INDESIT company

Model type:
LL65IT

Commercial code:
F028903

N1045072FIG1

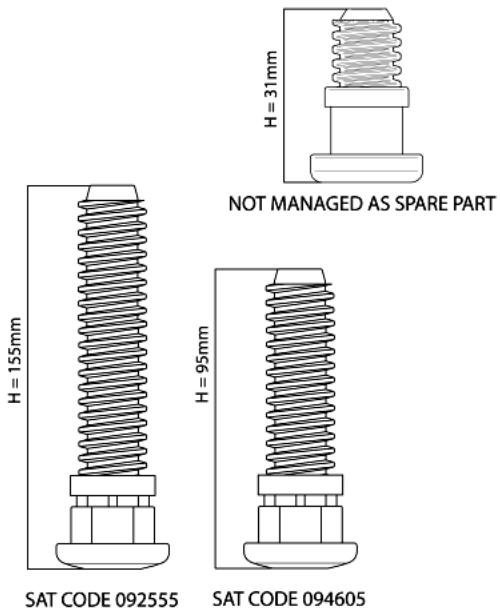
N1045072: Introduction of fixed rear foot H=31mm on free-standing models.

From serial no. 40218.0001, free-standing dishwashers affected by this modification have been equipped with new fixed rear feet (H=31mm).
The new foot replaces the adjustable one (H=155mm) Service code 092555; on the EVO3 range with TurboDry the new foot replaces the adjustable foot (H=95mm) Service code 094605.
The Spare Part Warehouse will continue to manage only 155mm and 95mm adjustable feet as they are interchangeable with the fixed 31mm foot.
The three feet are shown in illustration N1045072FIG1.

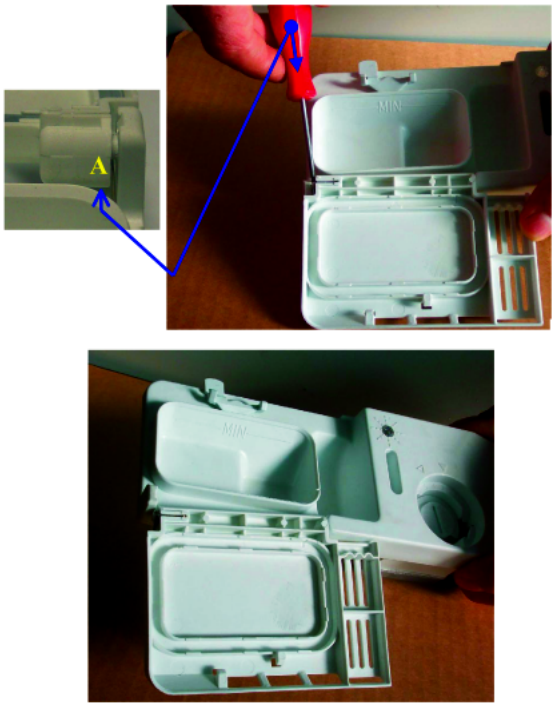
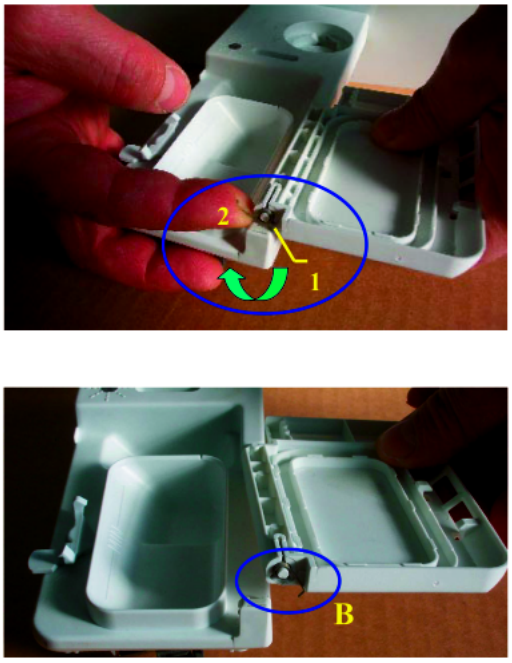
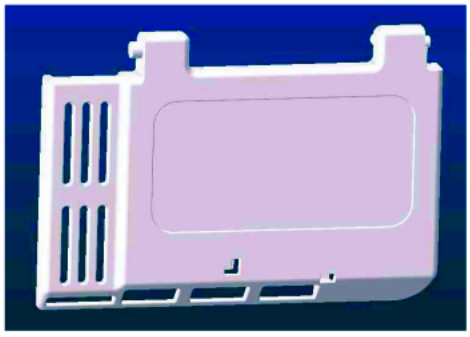
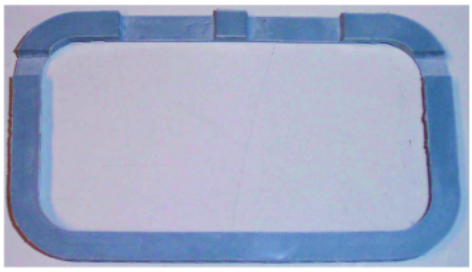
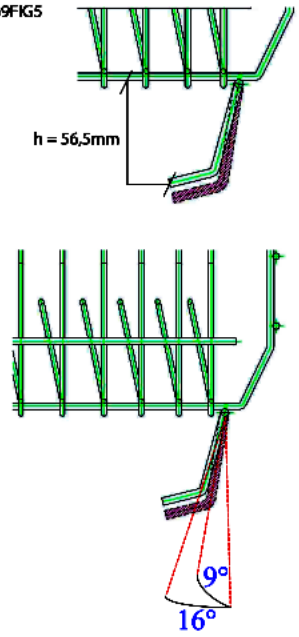
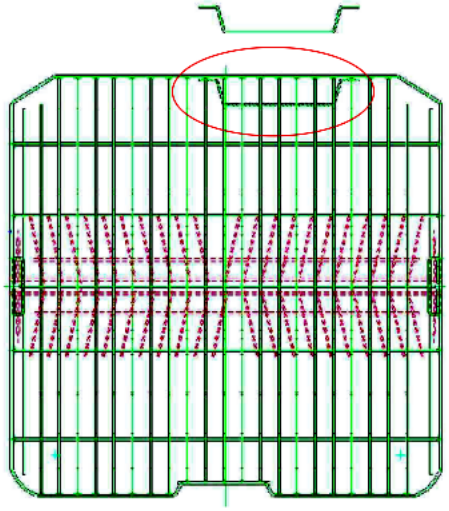
n1045069: Modification of racks and dispenser lid on EVO3 dishwashers

To obtain better dissolving of the detergent during the wash cycle, the following modifications have been made to EVO3 dishwashers:
- new dispenser lid, replacement code 098134 (see figure N1045069FIG4) created;
- upper racks modified with lid catch angle changed from 9° to 16° (see figure N1045069FIG5);
- MultiSystem lower racks modified with insertion of a spacer wire at the electric dispenser (see figure N1045069FIG6).

Lid installation instructions:
1) prise the lid out of the dispenser seat using a small screwdriver at point A (figure N1045069FIG1);
2) replace the lid, checking that release spring B (figure N1045069FIG2) is in place; before fitting the new lid load the spring from position 1 to position 2 (figure N1045069FIG2);
3) fit the lid in its special seat and check for correct operation (figure N1045069FIG3).
Lid closing may be harder for the first few cycles after replacement, due to settling of the material.

The upper and lower racks have the same spare part codes as the premodification items; Replacements Warehouse stocks have been replaced.

N1045080FIG1

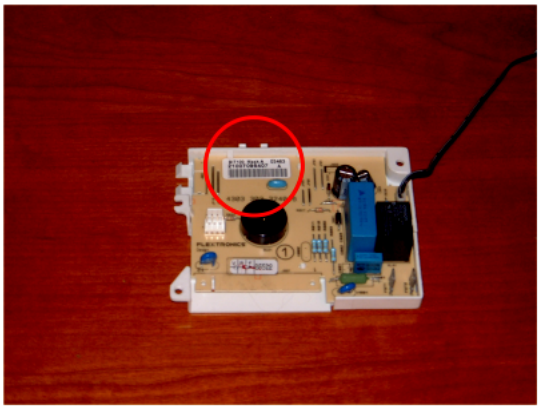
n1045080: Modification of front feet on free-standing DW.

From serial no. 40413.0001, free-standing dishwashers affected by this modification have been equipped with new front feet Service code 109991 in place of 056414.
The new foot is shown in fig. N1045080FIG1.

N1045083FIG1

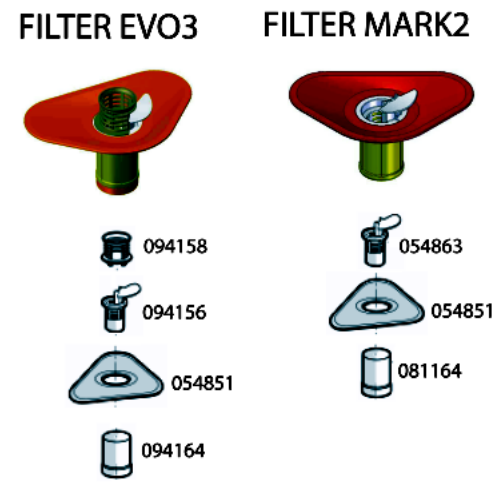
n1045083: Modification of filters on EVO3 60 cm dishwashers

All dishwasher models affected by this modification have been equipped with the items listed below, in order to solve the drain pump clooging problem.

Introduction of:
Cylindrical plastic filter code 081164
Central filter code 054863

Elimination of:
Cylindrical plastic filter code 094164
Central filter code 094156
Central filter grid code 094158

The modification has been introduced progressively, starting from serial no. 40516.0001.

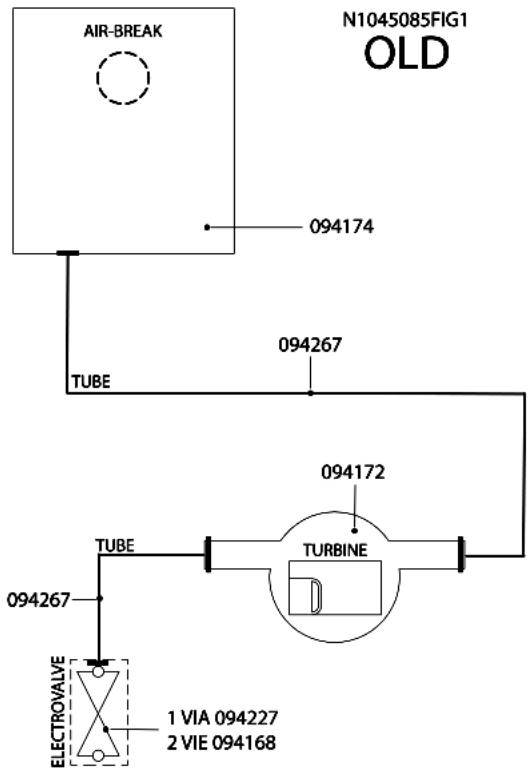
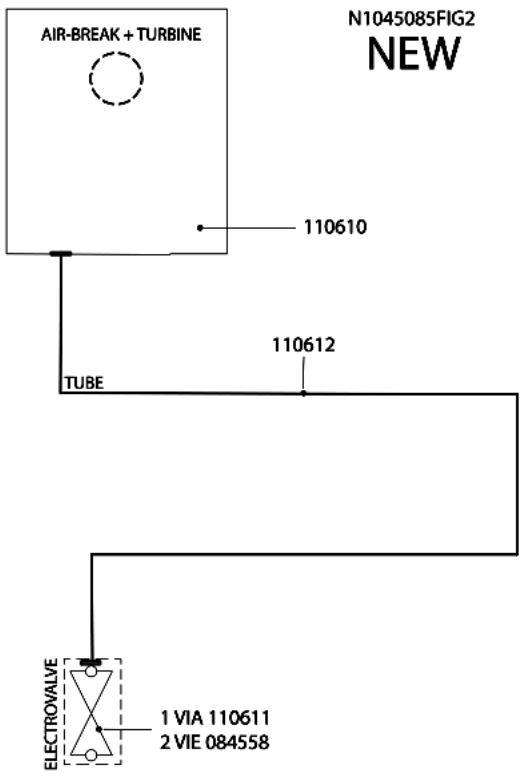
n1045085: Introduction of new litre counter turbine integrated on air-break.

All dishwashers affected by this note have been equipped with a new litre counter turbine on the air-break.
Picture N1045085FIG1 illustrates the premodification structure, picture N1045085FIG2 the new structure.

AIR-BREAK:
new 110610;
premodification 094174;
the new item features a new integrated litre counter turbine and its water supply hose has a smaller diameter.

LITRE COUNTER TURBINE code 094172 has been eliminated.

SOLENOID VALVES:
new:
1-WAY code 110611;
2-WAY code 084558(Rohs 143737);
premodification:
1-WAY code 094227;
2-WAY code 094168;
the new solenoid valves have a smaller diameter drain hose fitting.

HOSES:
new solenoid valve hose/air-break code 110612;
premodification turbine hose/air-break code 094267;
premodification solenoid valve hose/air-break code 094267;
the new hose has a smaller internal diameter.

N1045093FIG1
NEW FLAP UPPER BASKET SAT CODE 114799

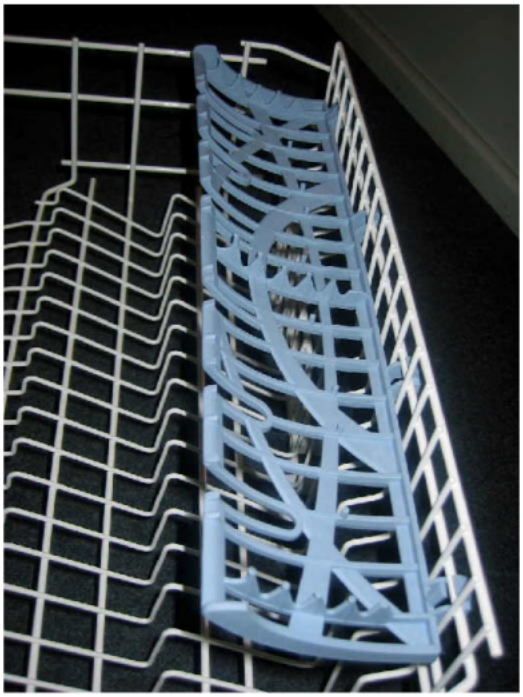
n1045093: Modification of light blue folding shelf attachment.

From serial no. 41109.0001 all models affected by this bulletin feature a modification of the folding shelf to upper basket coupling system.
This modification called for alteration of the relative baskets: the distance between the wire on which the folding shelf is attached and the wire below it has been increased from 9.5 mm to 17 mm, as shown in the attached image.
The altered folding shelves are not interchangeable and cannot be installed on premodification baskets: in the case of service interventions on product with serial number prior to 41109.0001 the entire upper basket must be replaced.
The baskets are reciprocally interchangeable and are managed as assemblies complete with their accessories, inclusive of folding shelves.

UPPER BASKET LIGHT BLUE FOLDING SHELF
new 114799 - premodification 094140.

UPPER BASKET ASSEMBLIES
new 115001 - premodification 094139;
new 115002 - premodification 094222;
new 115003 - premodification 094233.

Cod. 16001696000

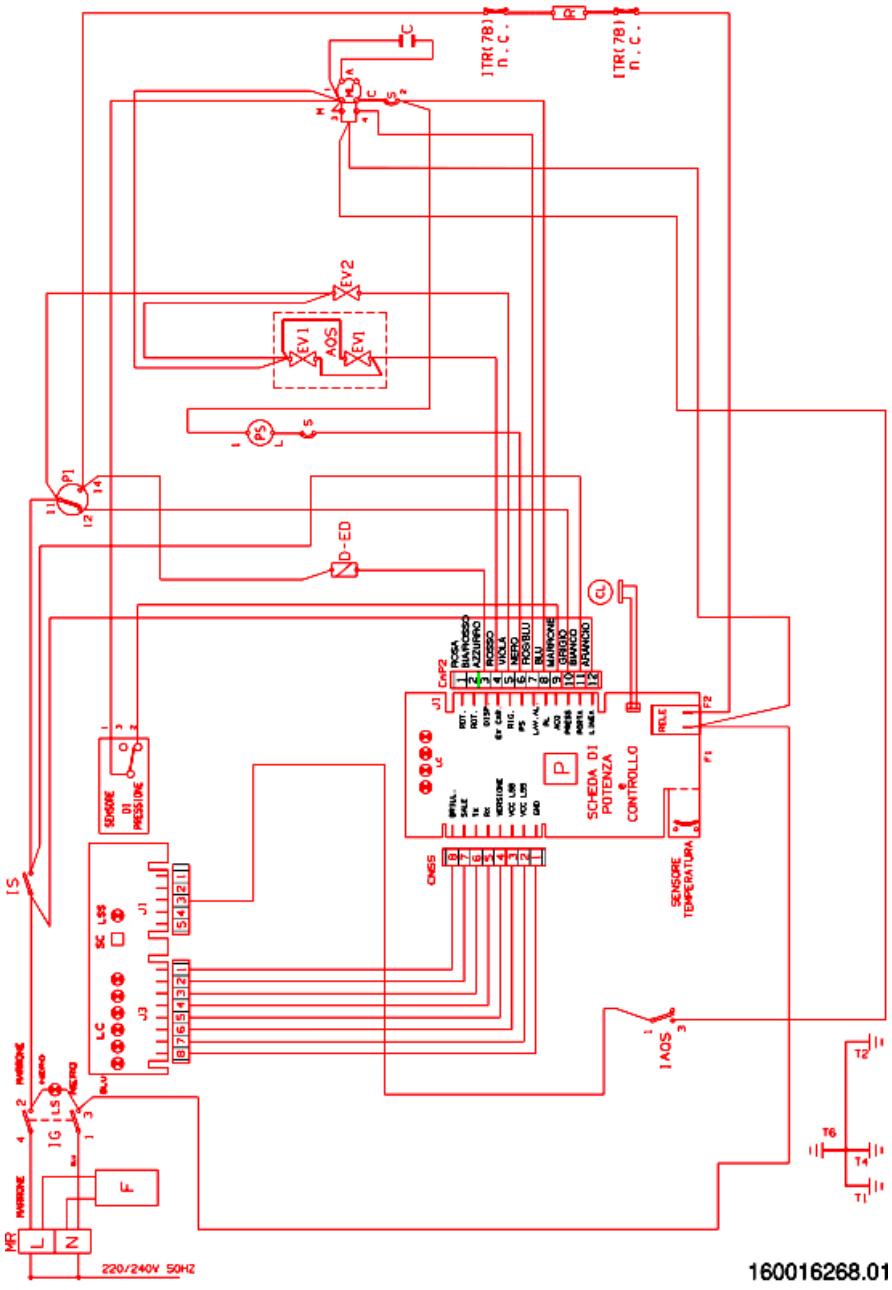
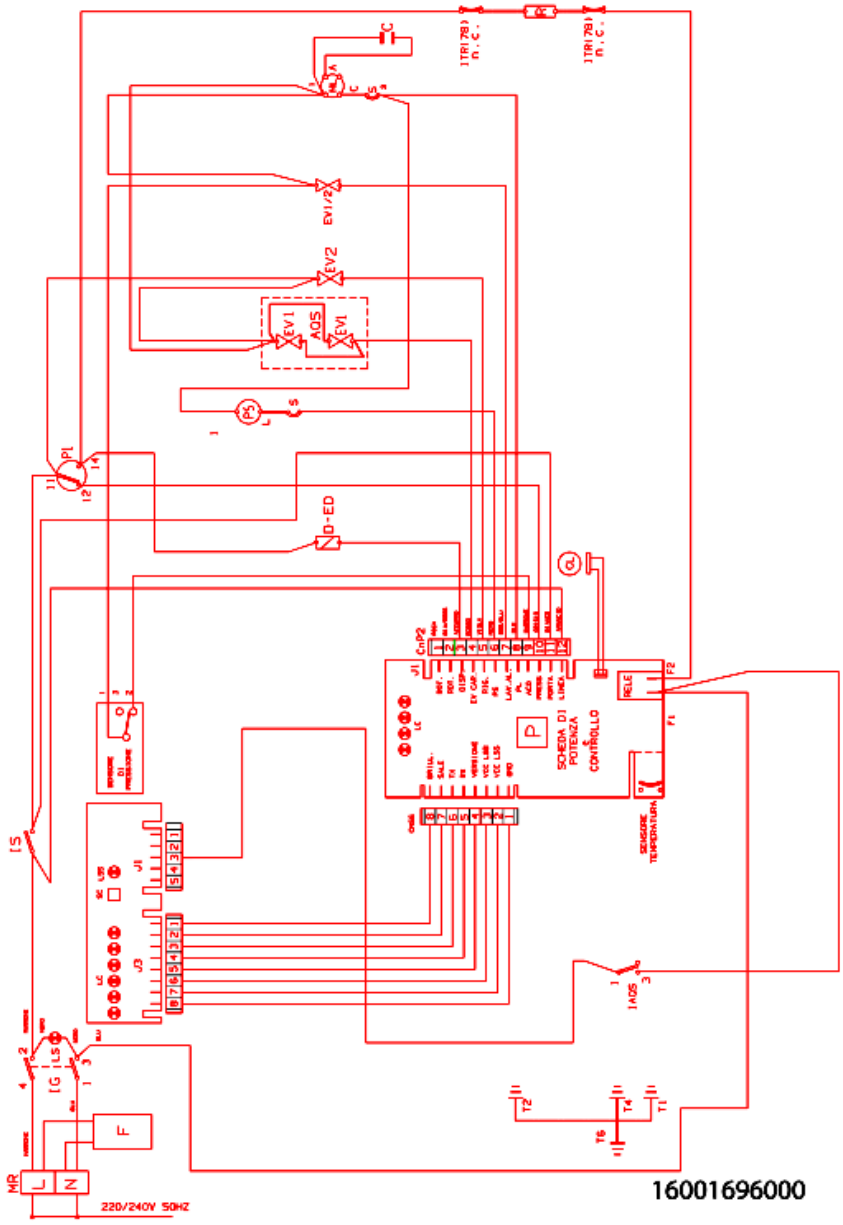
n1045070: Introduction of 1/2 load control with BIT 100 timer by means of solenoid valve.

EVO3 dishwasher models affected by this modification have been equipped with the new BIT 100 timer, in place of the alternating wash motor, that controls the 1/2 load system by means of a solenoid valve located on the volute of the electric pump.
Modified items:
- electric pump code 088896(W45V220P20) replaced with 077140(W75V220P24);
- electric pump code 088888(W45V240P20) replaced with 080512(W75V240P24);
- volute code 088889 replaced with 054979;

- BIT 100 timer code 094686 replaced with 097431;
- alternating wash motor code 077172 replaced with half load solenoid valve code 054985.

LL65IT Commercial Code 28903 Serial no. 31030.0001;
Wiring: new 098827 premodification 094130;
Wiring diagram: new 16001696000 premodification 16001626801.
